for official use only		
<b>CHANGE REQUEST NO. ILC-CR-NNNN</b>	EDMS No: <b>D*0XXXXXX</b>	Created: <b>27-08-2014</b>
		Last modified: <b>27-08-2014</b>

## **[ORIENTATION OF ELECTRON/POSITRON LINACS]**

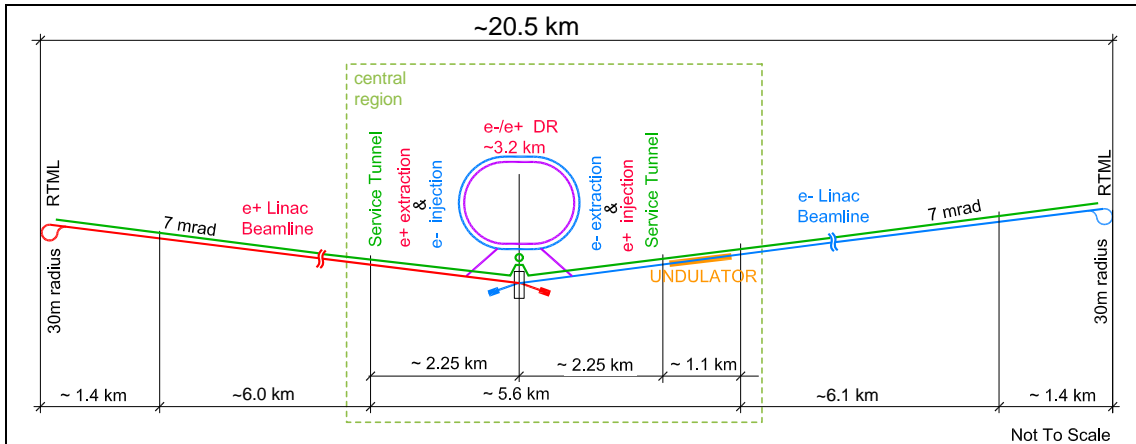
In the schematic layout of the ILC complex shown in TDR (Figure 2.1, TDR Volume 3.II), the electron linac is drawn on the upper side and the positron linac on the underside with the damping ring on the right side. The present change request is to flip the two main linacs, i.e., the electron- and positron-linacs are on the upper side and on the underside, respectively, with the damping ring on the right side.

The proposed site in Kitakami area is a granite area which is long in the north-south direction, therefore the main linac is to be constructed in the north-south direction. Since the elevation tends to be lower in the west side, all the portals of the access tunnels, as well as the damping ring, should be on the west side of the main linacs to minimize the total length of the access tunnels. Since the elevation tends to be higher in the north compared to the south, and the arrangement of the utility caverns is not symmetrical with respect to the interaction point, the total length of access tunnels can be minimized by flipping the electron- and positron linacs. The current siting study suggests the total length of access tunnels would be minimized if the electron linac is on the north side and positron on the south side.

Our geological survey shows we can expect nice and uniform geological condition within a few kilometers from the candidate site for the interaction point. The damping ring, therefore, can be constructed on either side of the interaction point from the viewpoint of the geological condition.

This flipped layout is consistent with a possible future upgrade to the 31km long machine (500GeV machine).
